Addendum #2

Date: December 17, 2025

Subject: Addendum #2
H&P Project # 2025087
Seneca Park Phase 1 Water & Sewer
Campbell County, VA

Dec 17, 2025 - 8:38am Z:\2025\20250807\eng\engineering\CAD\250807_SWR-VTR_PLAN AND PROFILE.dwg

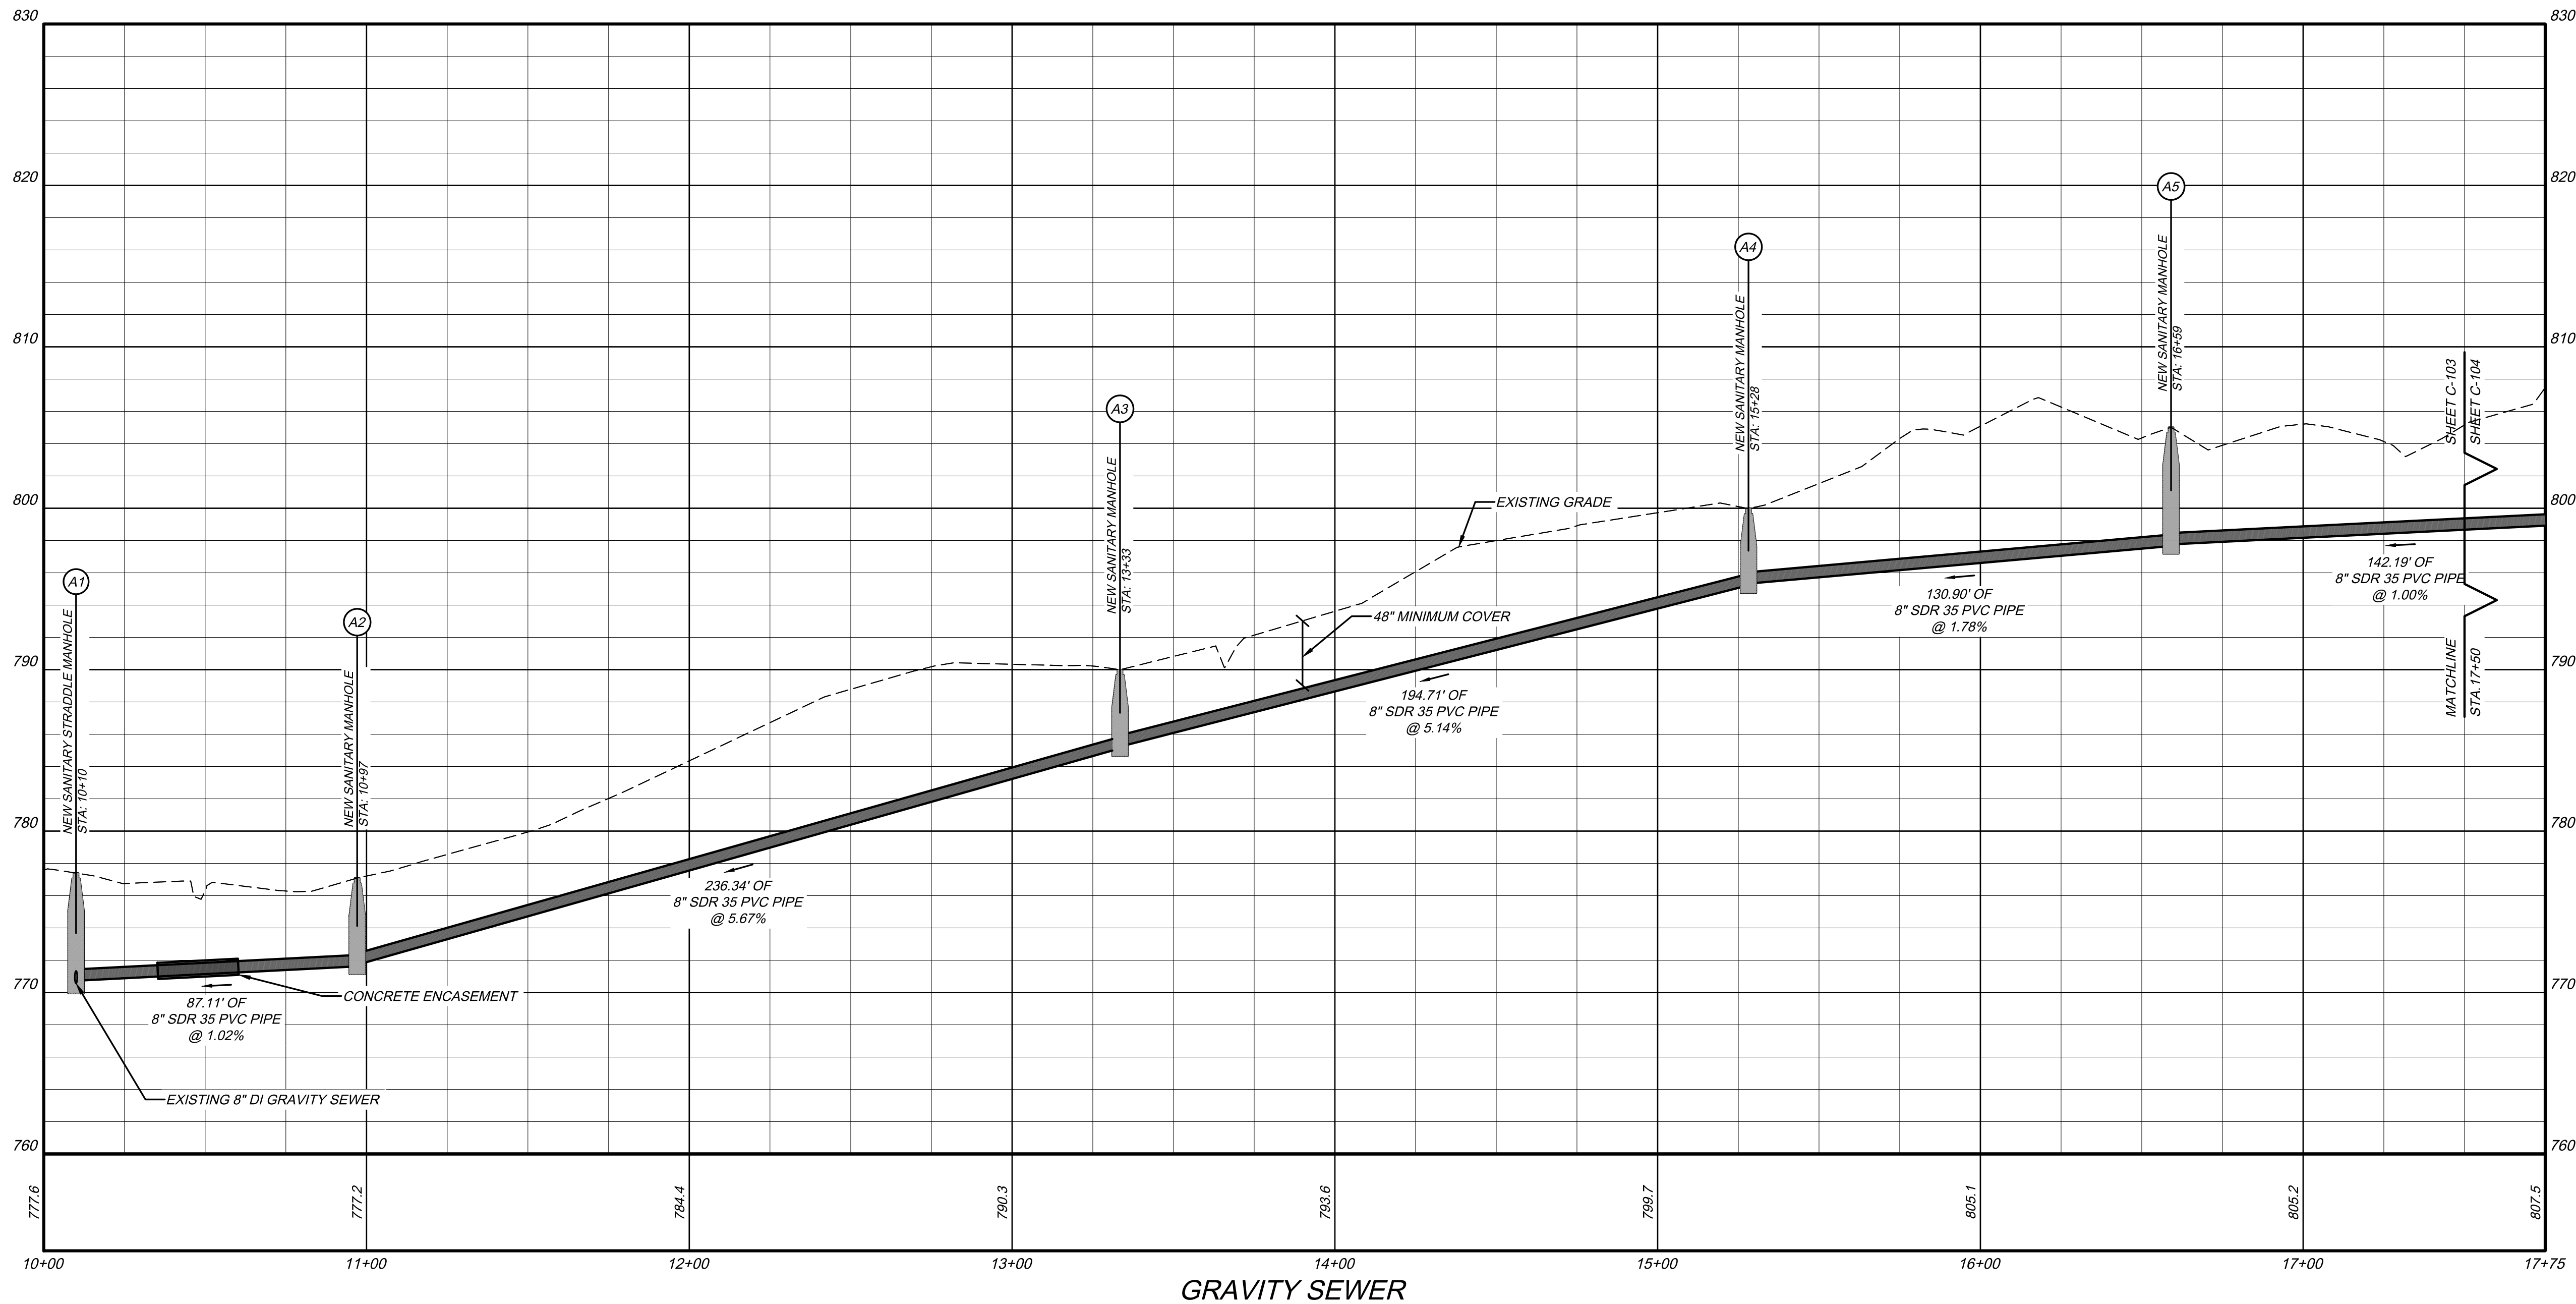
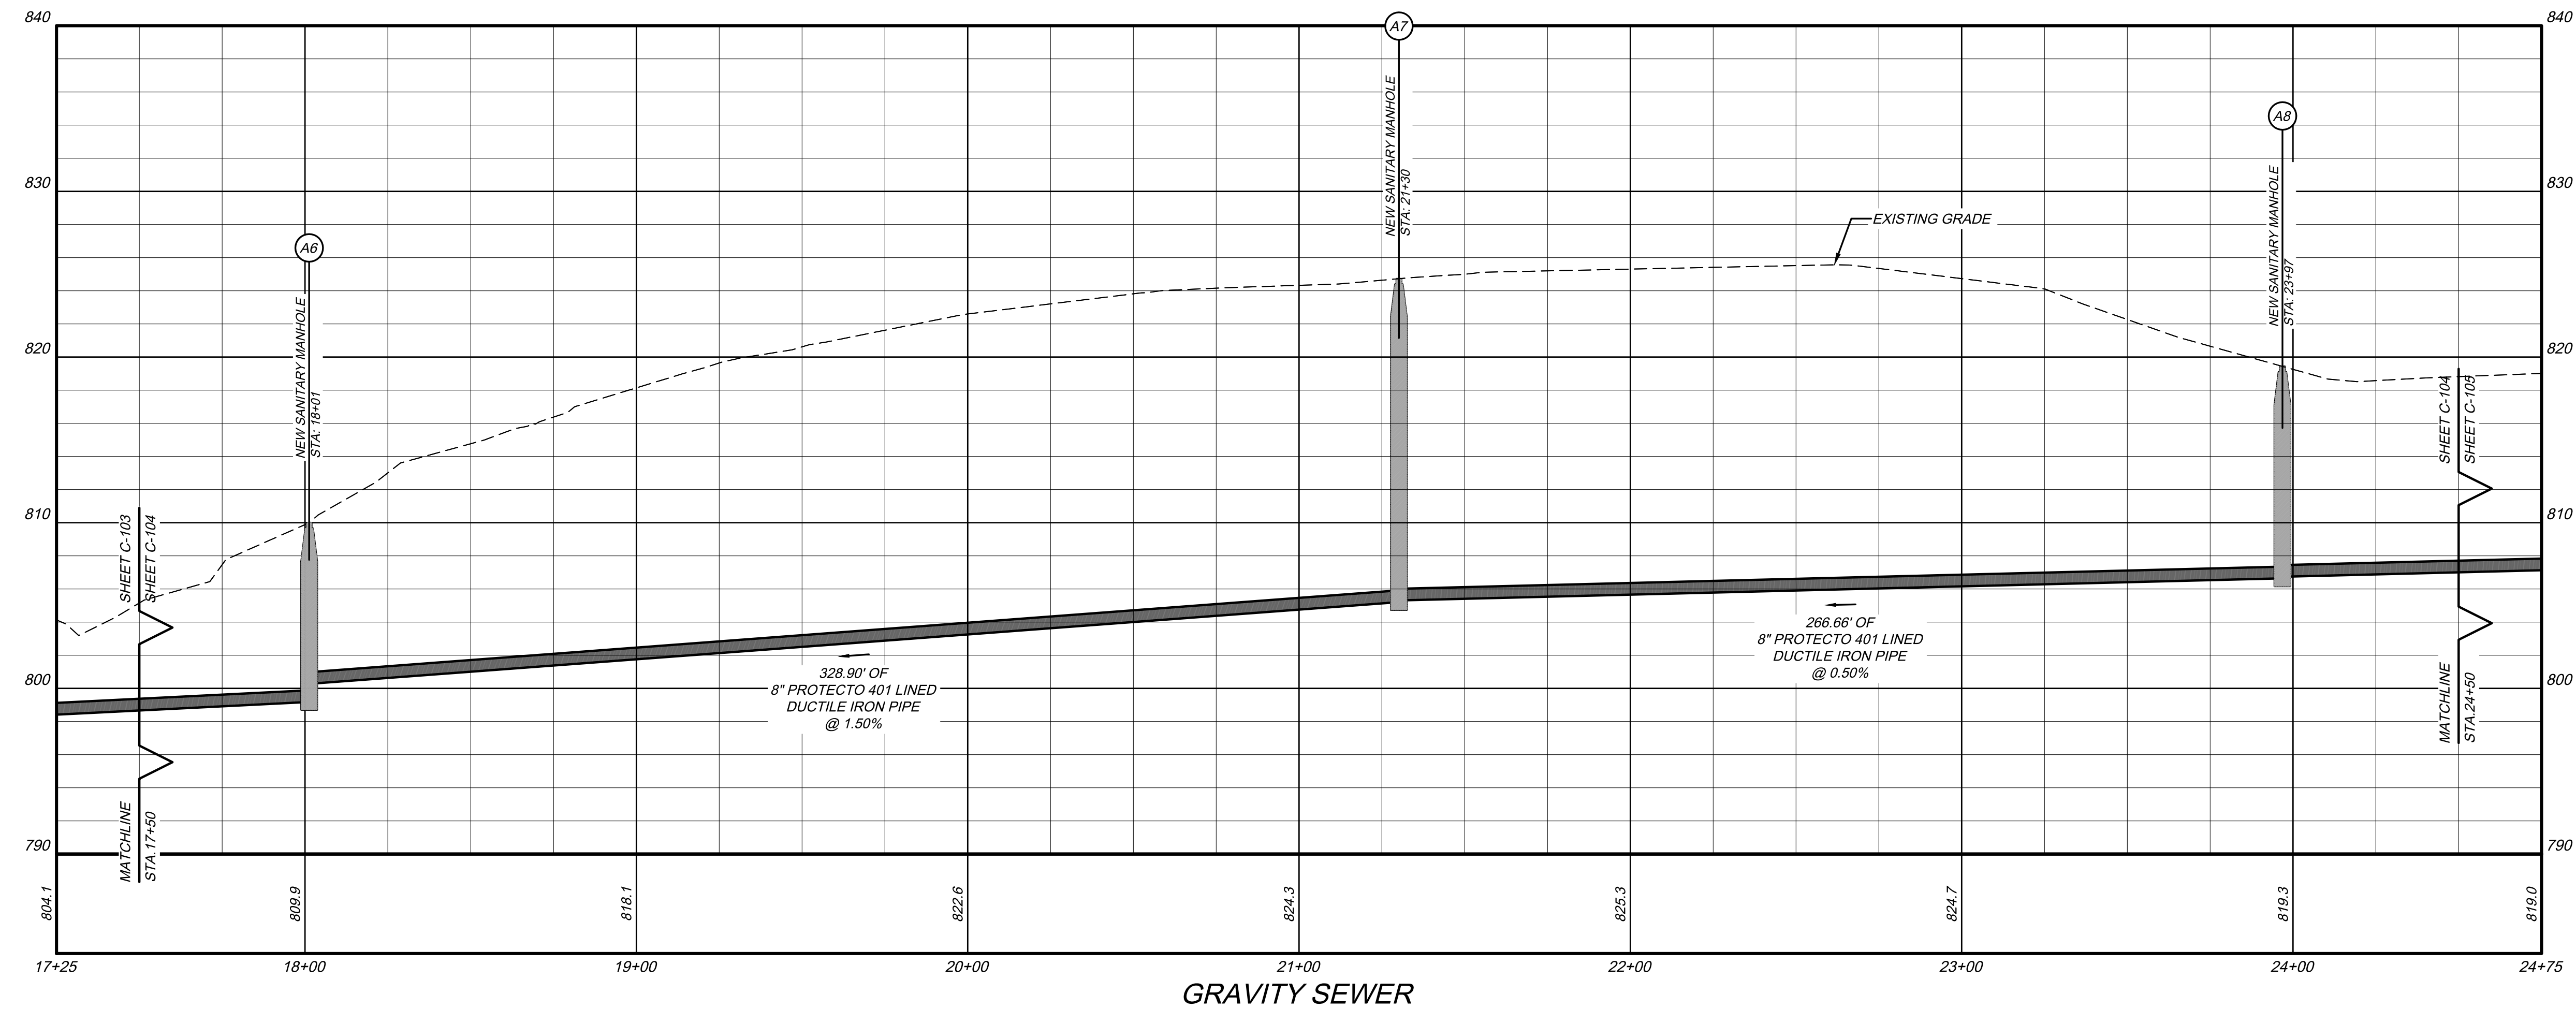
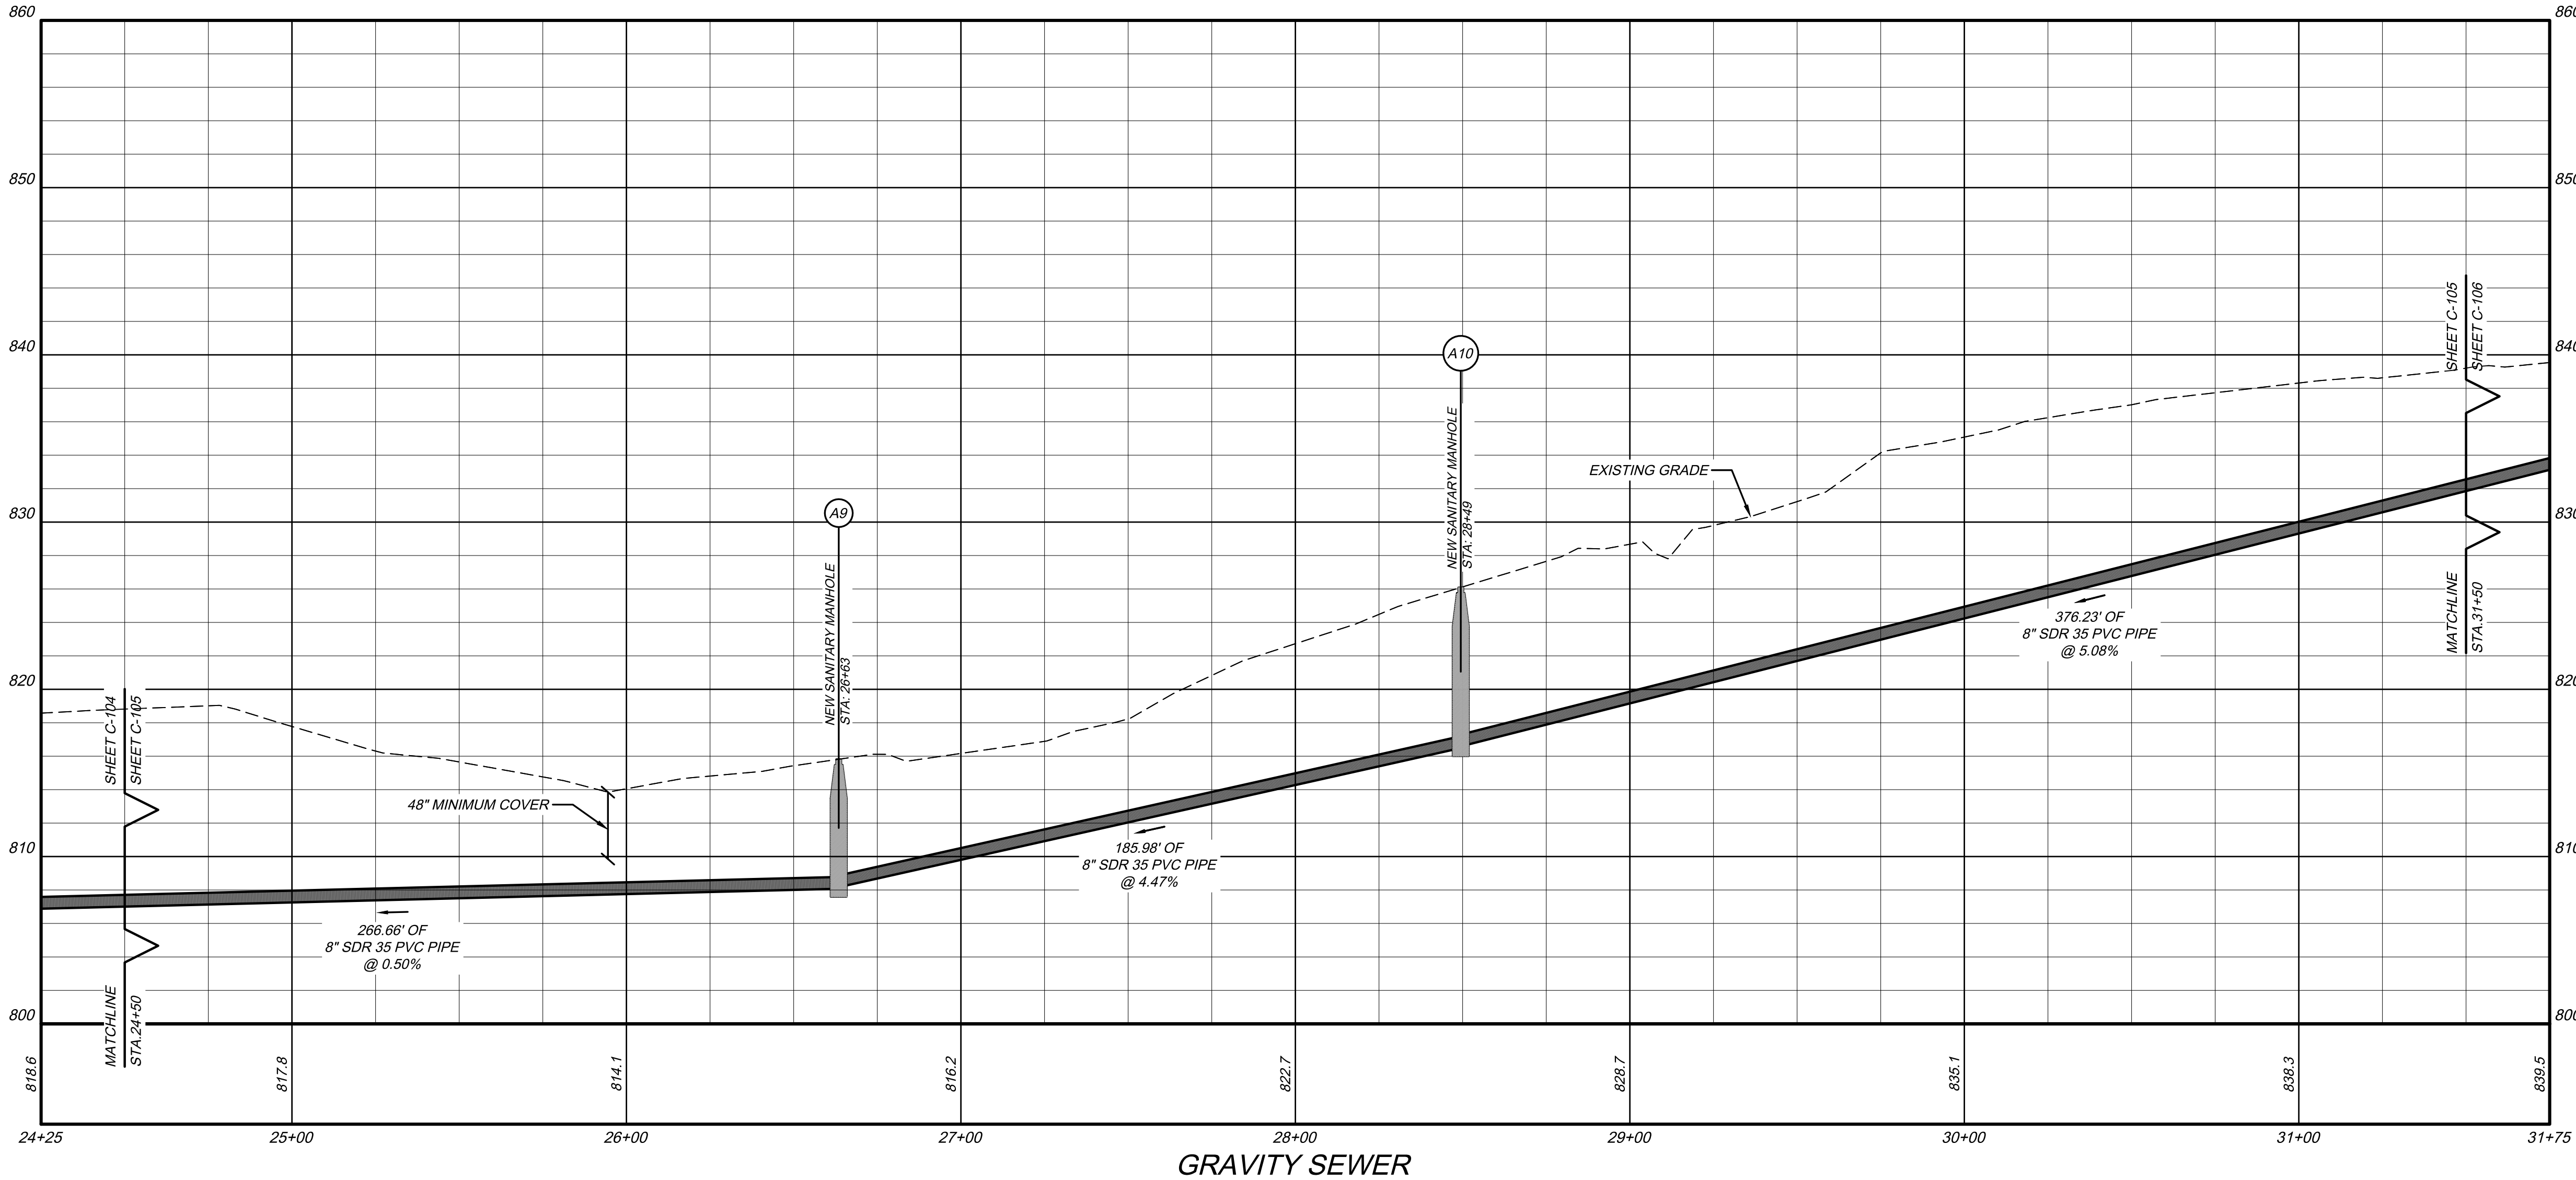
Item Ten: Silt Fence

Silt fence lengths have been updated on the plans based on County comments. The updated quantity has been revised on the bid form.

Updated plan and profile sheets will be included with this Addendum to show the added silt fence and updated water line structure. All changes will be clouded.
